Staff Report to the Technical Review Committee June 3, 2014

MCDONALD'S PLAT @

JOHN YOUNG PKWY & SILVER STAR ROAD

The applicant proposes a minor one lot plat for the construction of a McDonald's at the corner of John Young Parkway and Silver Star Road.

PROPOSED PLAT

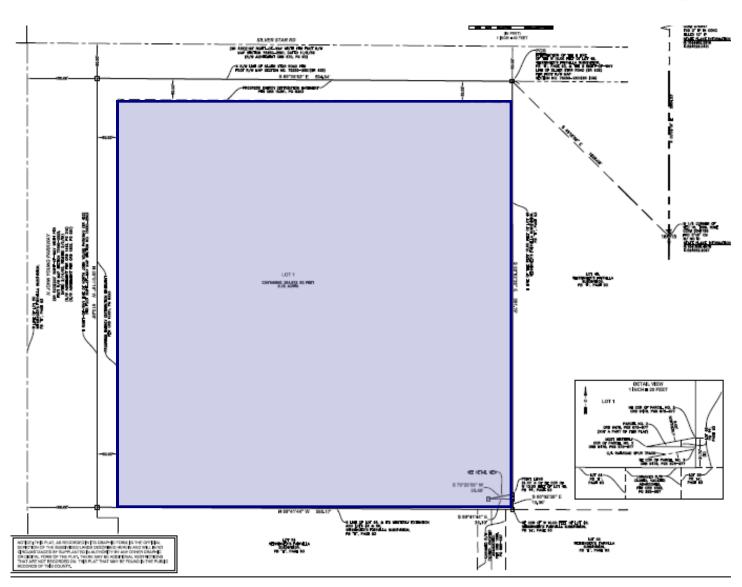
- 2. City Surveyor- The plat shall be subject to the requirements of the City Surveyor, as attached:
 - A. Survey: Abbreviations/symbols listed below are missing or need to be revised.

- 1. (BS)
 - 2. SR
 - 3. TP
 - FAC 5j-17.051(3)(b)11b
 - B. Title, Plat, and Survey: References to Silber Star Road as SR 438 should be changed to SR 416 for this portion. The FDOT R/W references to FS 177.091 (11) & (15)

- C. Title Survey, Plat: Spell out FDOT in the descriptions.
 - D. Plat: Abbreviations/symbols listed below are missing or need to be revised.
 - 1. CL
 - 2. COR

- 3. E:
 - 4. N:
 - 5. R/
 - 6. SR
 - FS 177.091 (29)
 - E. Closure reports were not submitted
 - F. Field Review has not been completed at this time. Email Dean Hill and copy me to schedule future field checks. Dean can be reached at dean.hill@cityoforlando.net. FS 177.091(7)

- 3. Legal-Incomplete submittal. Comments will follow upon submission of required documents
- 4. Change "Silver Star Rd" to "Silver Star Road" on the plat title for consistency
